1 k) Original Flooring Treatment

Heritage Council Comment 1 k)

TYPICAL DETAIL - FLOOR TYPES 01, 14, 39 AND STC LEVEL 1 - FLOOR/CEILING TYPES 55, 56 AND 57

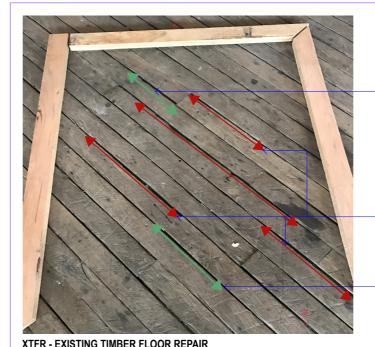
The original ironbark flooring in both Wharves is proposed to be retained in-situ. However, new flooring is required in areas such as kitchens and toilet facilities. Further design details of how the ironbark flooring will be retained and protected prior to the new flooring structure being installed above must be provided to the Heritage Council for assessment prior to approval of this project.

The original ironbark flooring is to be generally retained and protected. Where new finishes are proposed over the original flooring a double layer of 0.2mm thick plastic sheet, taped and sealed, will be installed to protect the original timber flooring from damage.

Equitable access underpins the adaptive reuse of the pier. To comply with accessibility codes it is necessary to remove the top layer of the original timber flooring in limited areas such as to the accessible bathrooms and commercial kitchens. The extent of this intervention has been carefully considered to minimise heritage impact, and is restricted to floor types 3, 8, 9, 10, 40, and 44.

More than 5mm vertical height variation. Sand high section, sanding to be kept to an absolute minimum on raised boards only. Sand with 100grit only, not high polished.

More than 10mm gap between boards required to be filled. Fill gaps with scribed timber fillet.

No finish to existing floor. Minimise floor repair and sanding in line with heritage requirements.

Provide a 3mx3m fully finished prototype of the repairs for approval by the Architect and Heritage Architect prior to undertaking any work on the existing floors.
